Generic Evaluation of Feedwater Transients and Small Break Loss-of-Coolant Accidents in Westinghouse-Designed Operating Plants

**Office of
Nuclear Reactor Regulation**

**U.S. Nuclear Regulatory
Commission**

**Bulletins and Orders Task Force
Office of Nuclear Reactor Regulation
U.S. Nuclear Regulatory Commission
Washington, D.C. 20555**

Figure 1.

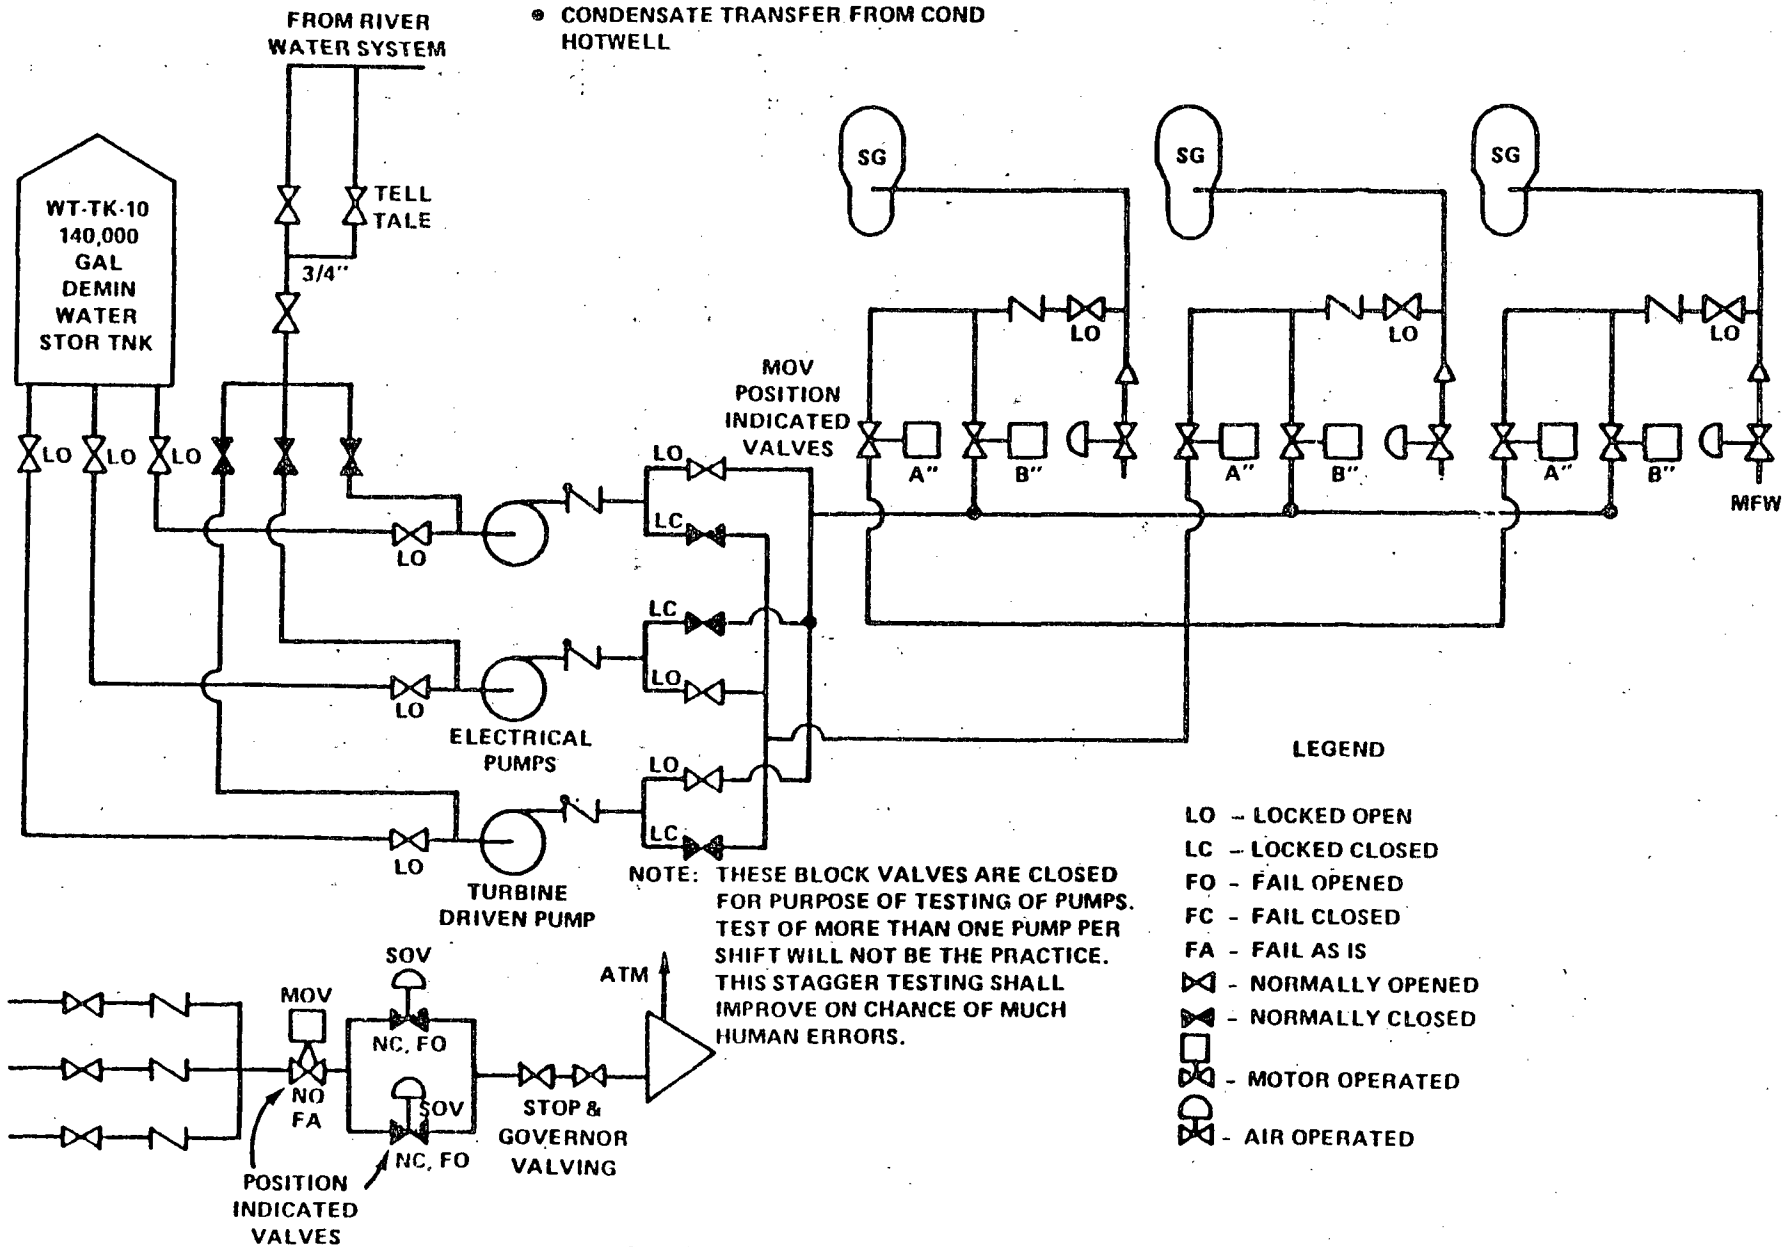
7. Recommendation - As shown in Figure 1, the locked block valves in each AFW pump discharge line are aligned so that the combined flow from one motor-driven pump plus one turbine-driven pump is supplied to the steam generators via one AFW header while flow from the remaining motor-driven pump is supplied to the steam generators via the redundant AFW header. As indicated in Section 1.1.1, the licensee states that, in the event of an unisolable main steam or main feed line break, the flow from both motor-driven pumps or from the turbine-driven pump is required to prevent dryout of the steam generators. The licensee should review the present alignment of the AFW pump discharge block valves and modify as necessary to provide the AFW required for normal, transient, and accident conditions.

Long-term recommendations for improving the system are as follows:

Auxiliary Feedwater System
Ginna
Figure 1 (Sheet 1)

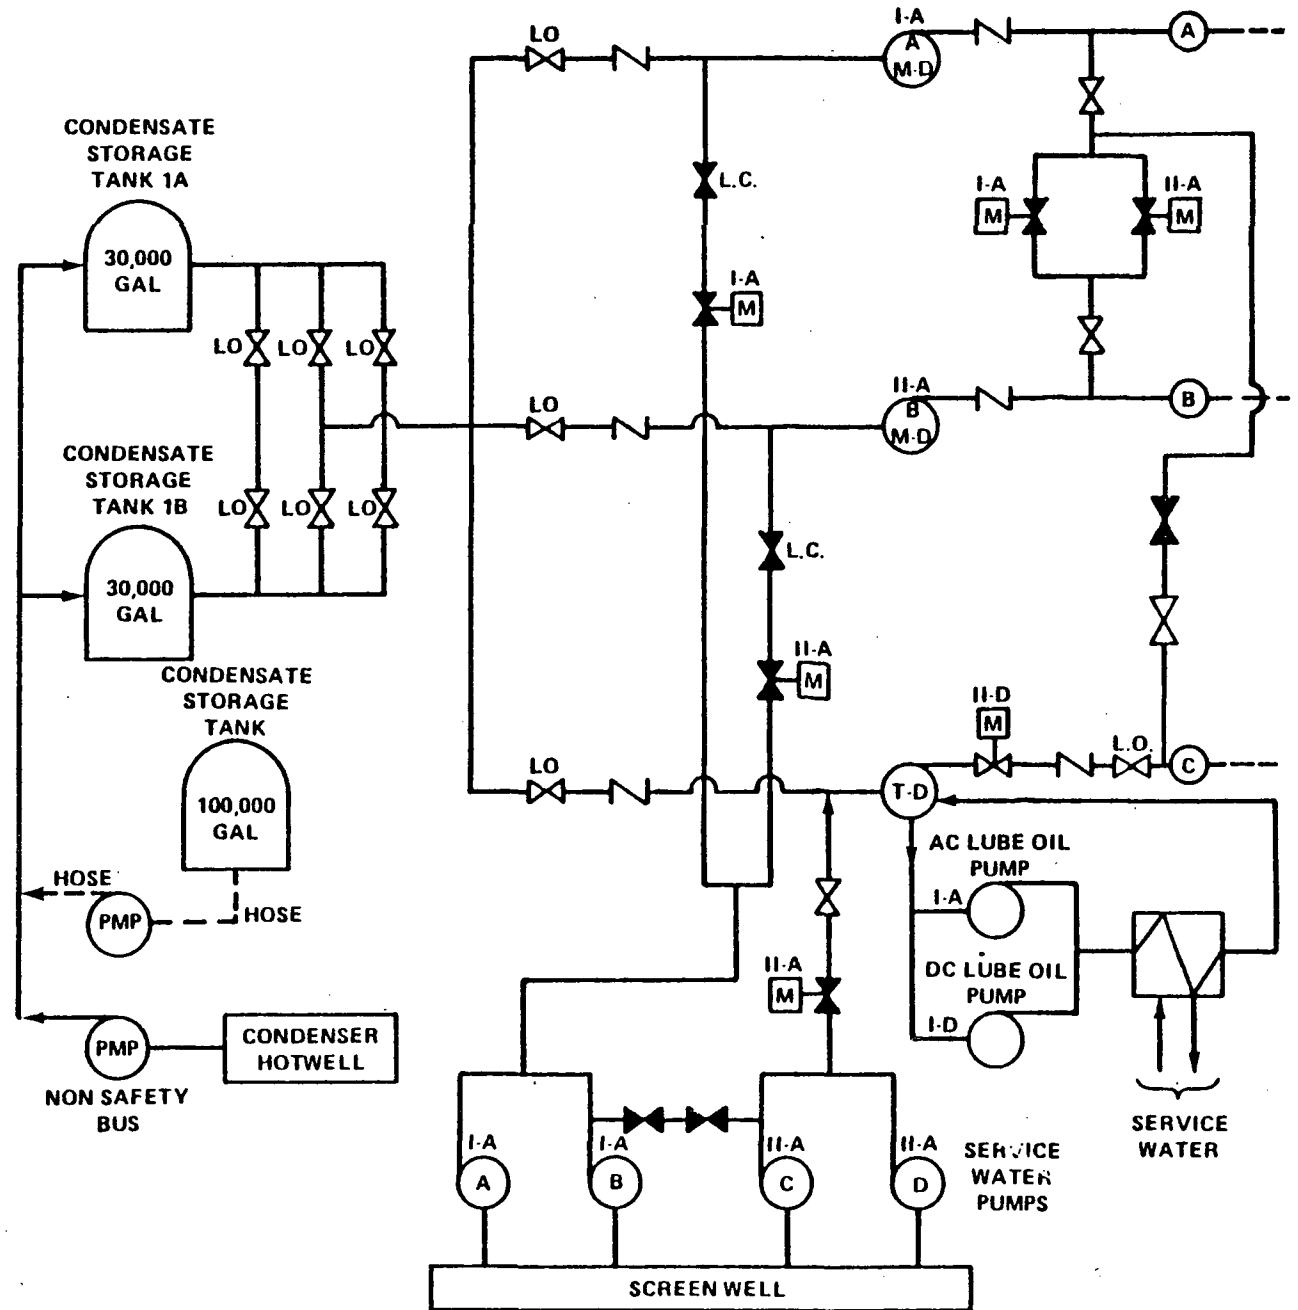
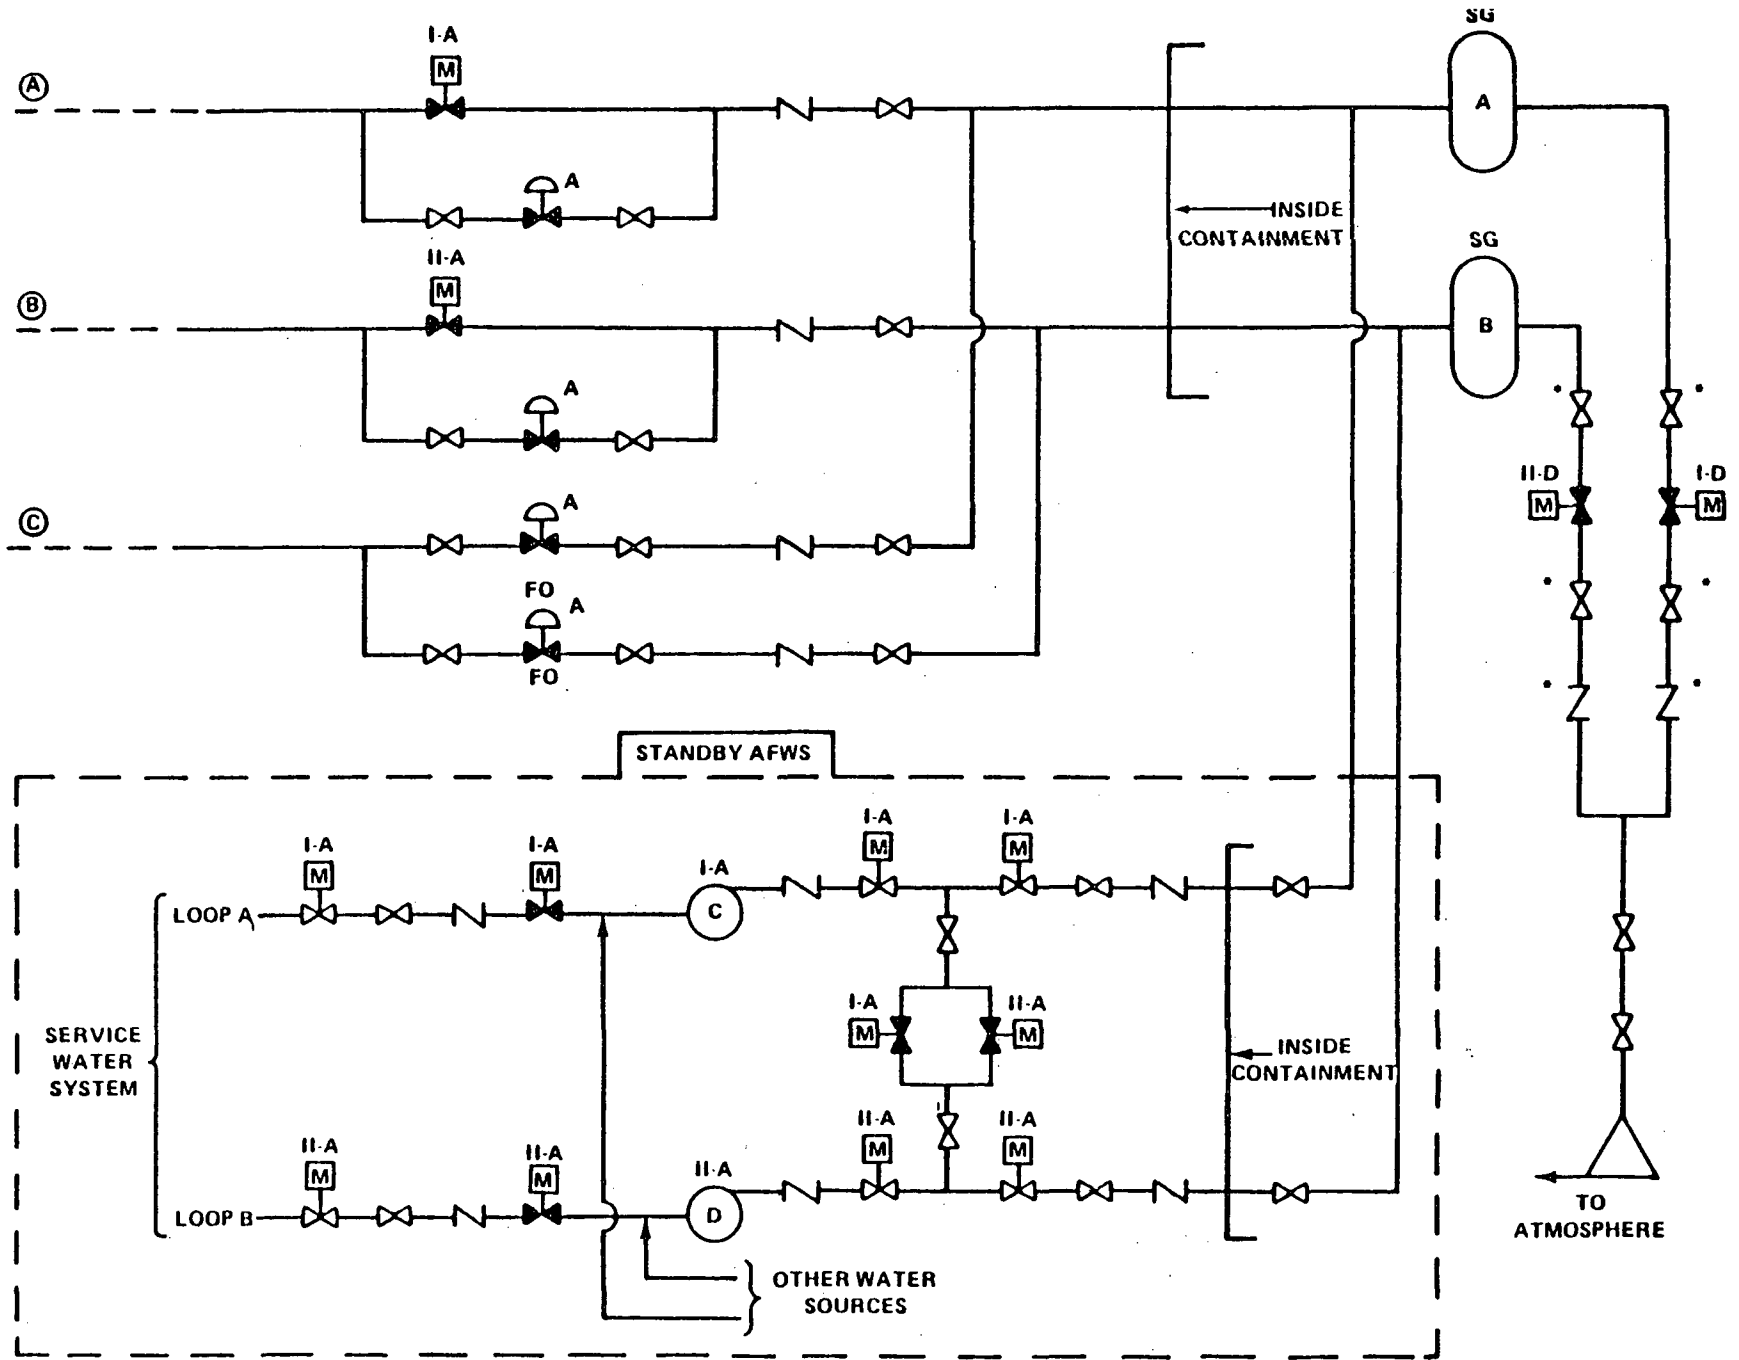
4. There is no provision for either the main or standby AFWS 's to automatically terminate flow to a depressurized steam generator and automatically provide flow to the intact steam generator. This is accomplished by the control room operator. The lack of this automatic capability will be further evaluated as part of the Systematic Evaluation Program.

5. The main and standby AFWSs will be reevaluated for internal and external missiles, seismic design requirements, and flood and tornado protection as part of the Systematic Evaluation Program.

Auxiliary Feedwater System
Kewaunee
Figure 1

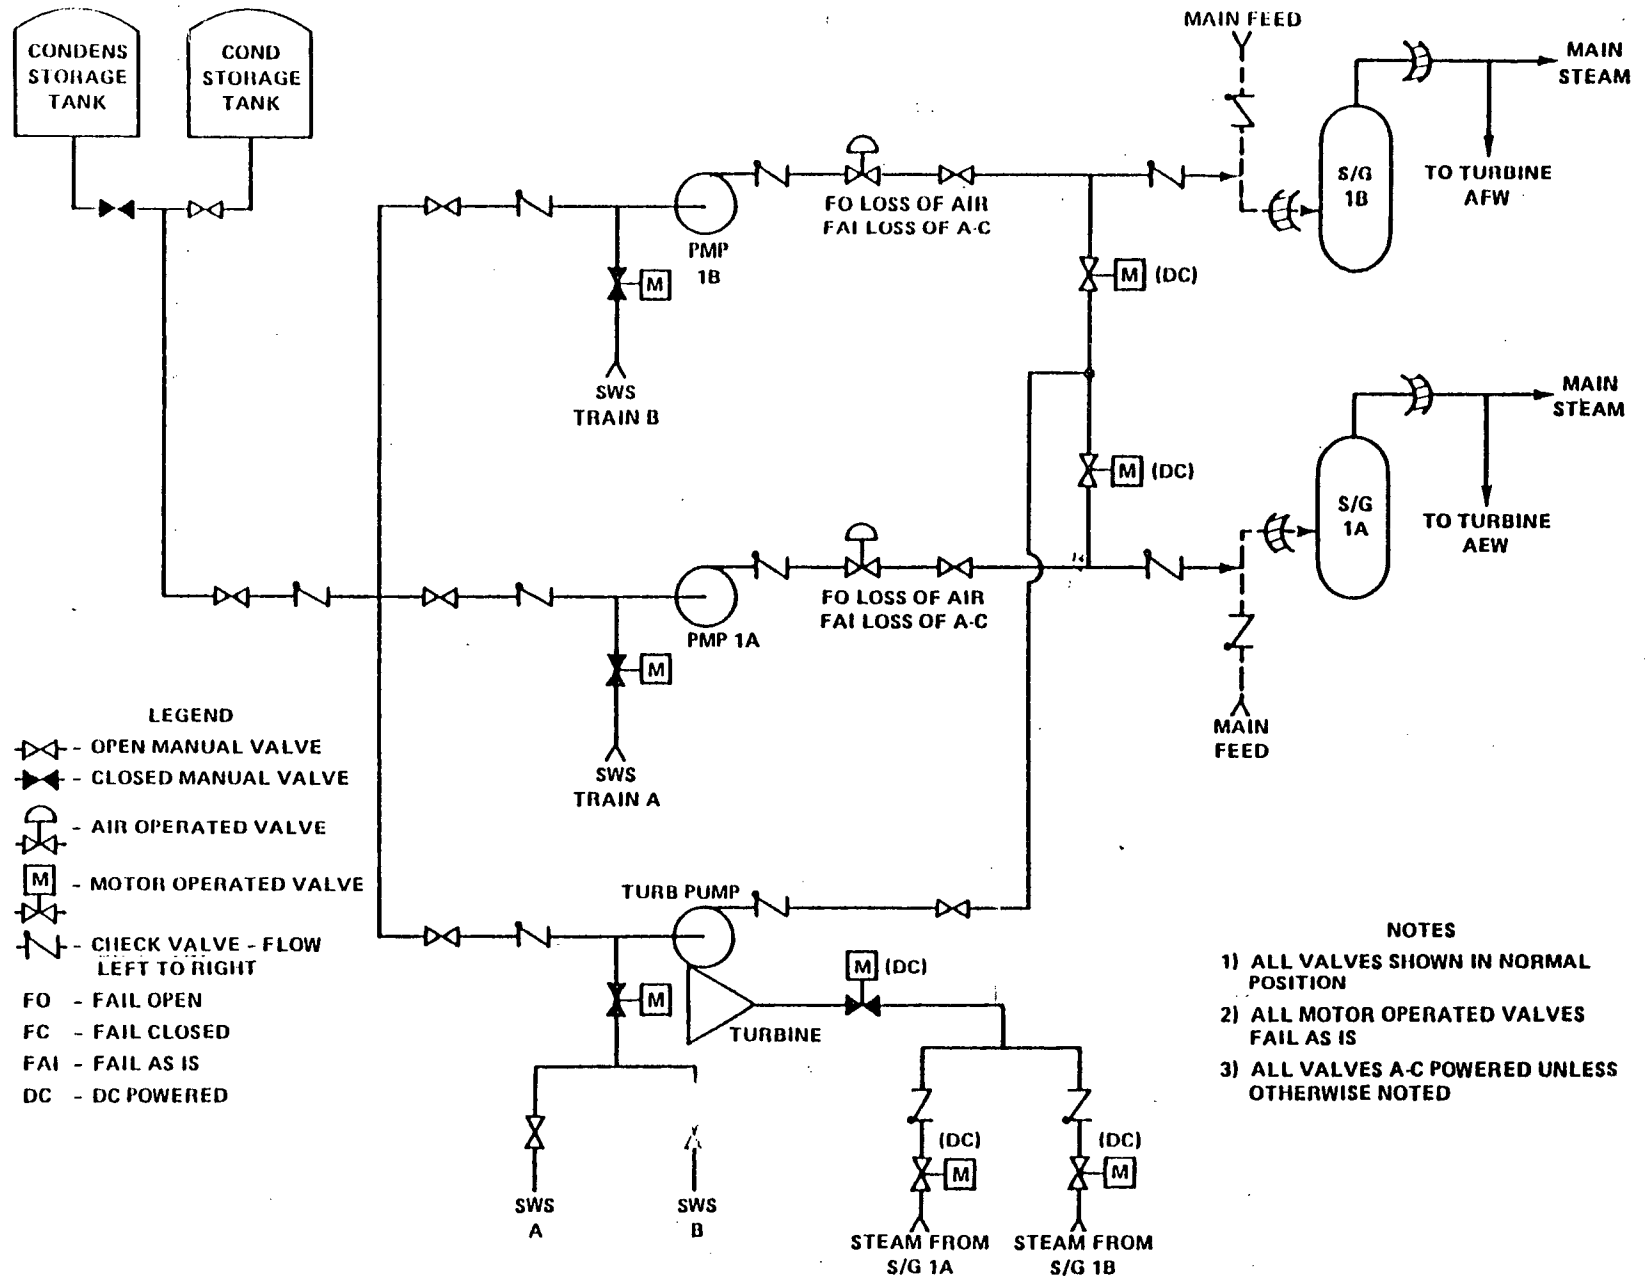
1. Recommendation GL-2 - Licensees with plants in which all (primary and alternate) water supplies to the AFW systems pass through valves in a single flow path should install redundant parallel flow paths (piping and valves).

Licensees with plants in which the primary AFW system water supply passes through valves in a single flow path, but the alternate AFW system water supplies connect to the AFW system pump suction piping downstream of the above valve(s), should install redundant valves parallel to the above valve(s) or provide automatic opening of the valve(s) from the alternate water supply upon low pump suction pressure.

Auxiliary Feedwater System
North Anna
Figure 1

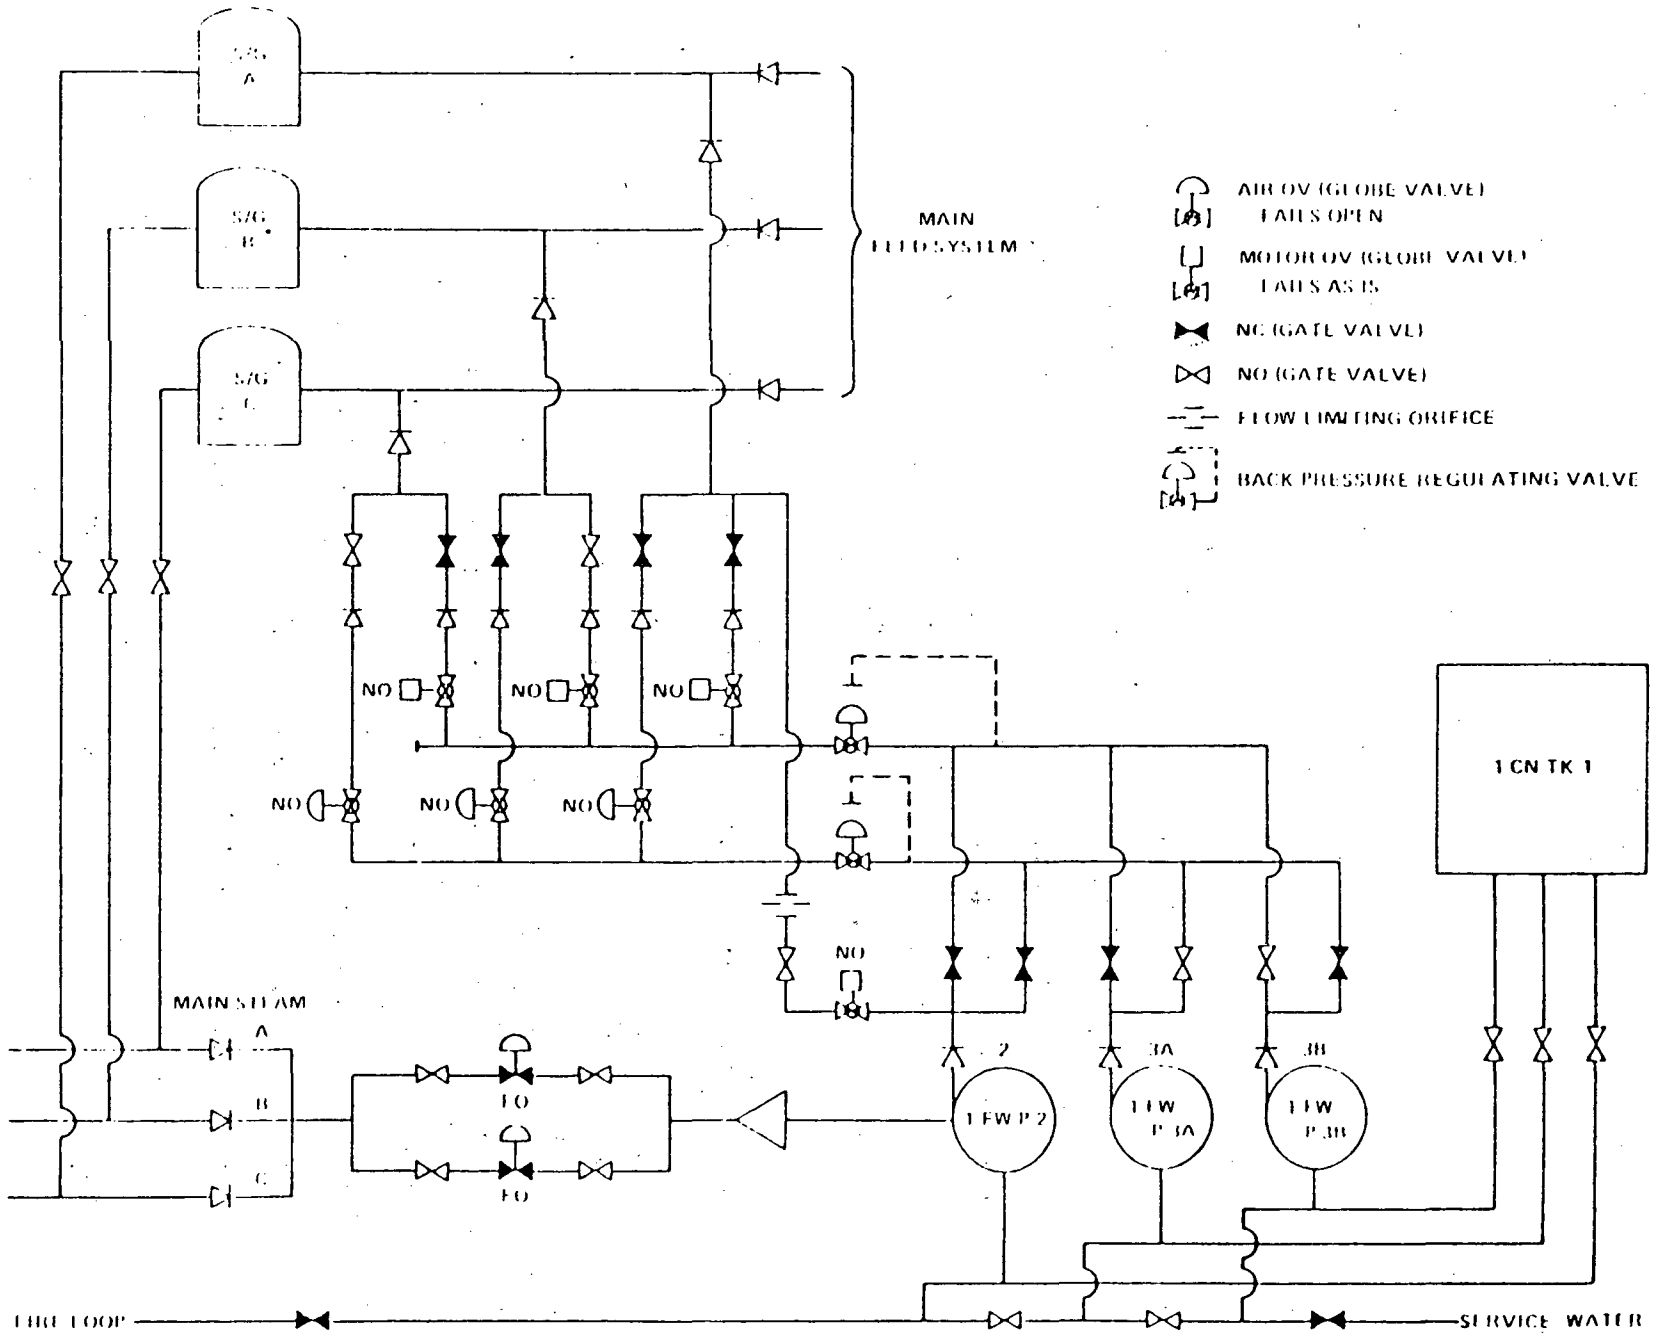
4. Recommendation - Licensees with plants which require local manual realignment of valves to conduct periodic tests on one AFW system train and which have only one remaining AFW train available for operation, should propose Technical Specifications to provide that a dedicated individual who is in communication with the control room be stationed at the manual valves. Upon instruction from the control room, this operator would re-align the valves in the AFW system train from the test mode to its operational alignment.
